IEC/IEEE 60802 Digital Datasheet

Lukas Wüsteney,
Stephan Kehrer, **Hirschmann Automation and Control GmbH**

Current state in IEC/IEEE 60802 D1.4

Figure 31 – Creation of the digital data sheet of an IA-station

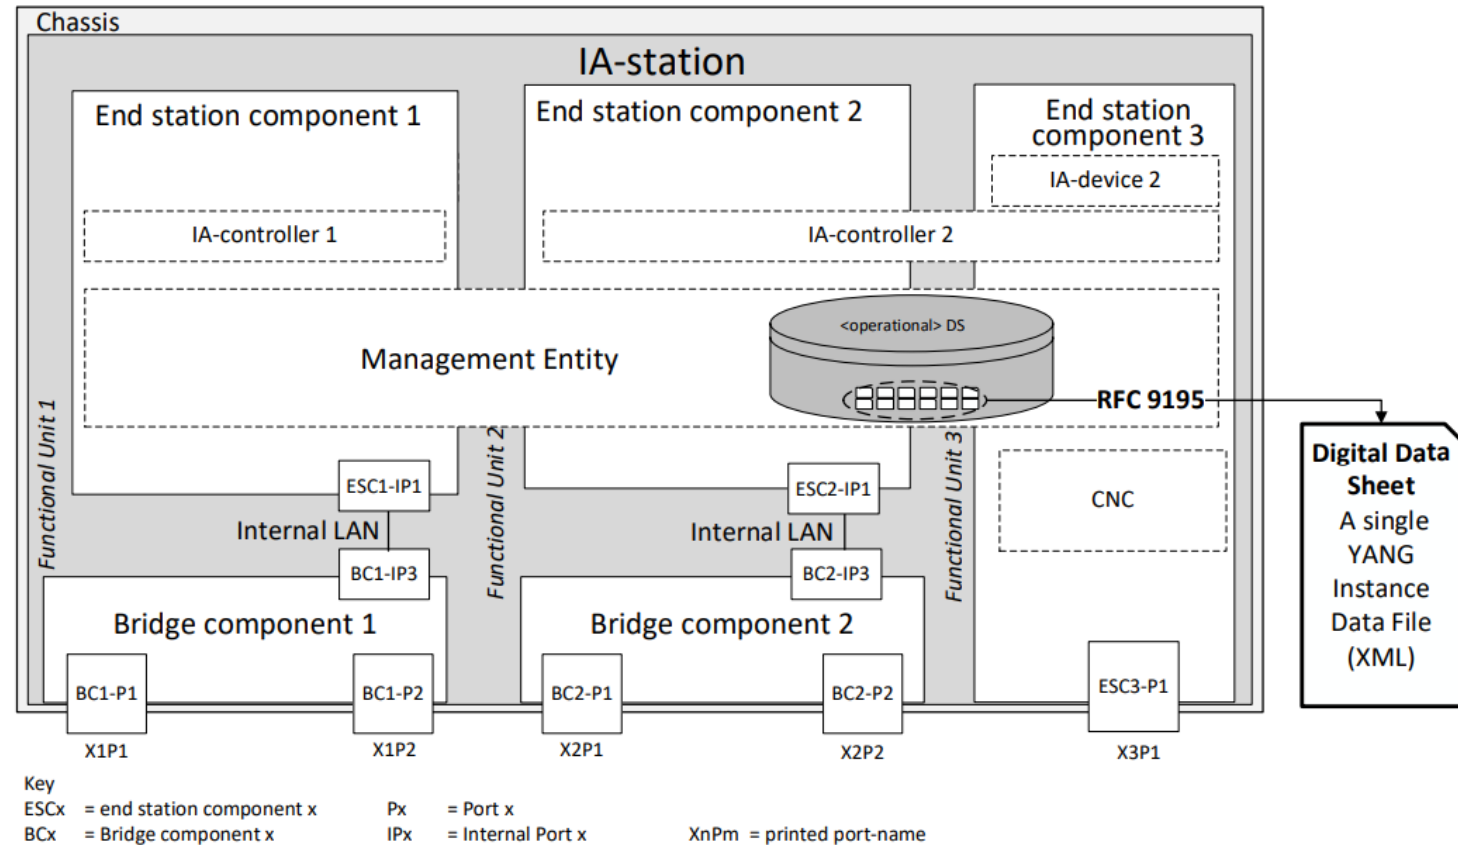
With the current statement on how to generate the Digital Datasheet two issues exist that should be addressed:

1. There is no overview in IEC/IEEE 60802 on what the Digital Datasheet contains (i.e., what objects exactly are exported to create the Digital Datasheet).
 - This makes it hard for readers of the profile to understand the contents of the Digital Datasheet.
 - The Digital Datasheet most likely will differ from vendor to vendor, especially if vendor specific information is included.
2. The Digital Datasheet will contain information that is not useful in the context of a datasheet, e.g., statistics counters or the configuration of specific features. This leads to a convoluted datasheet that is hard to understand and requires more memory than necessary.
 - Examples for unnecessary information currently ending up in the datasheet are
 - Statistical data: `/ieee802-dot1ab-11dp/11dp/remote-statistics`
 - Configurable objects: `/ieee802-dot1ab-11dp/11dp/port/notification-interval`

Problem: Some objects for capabilities/quantities are missing in existing YANG modules. In order to get them into the Digital Datasheet they need to be defined somewhere.

Proposed solution: Define the context and structure of the Digital Datasheet as a YANG module in IEC/IEEE 60802.
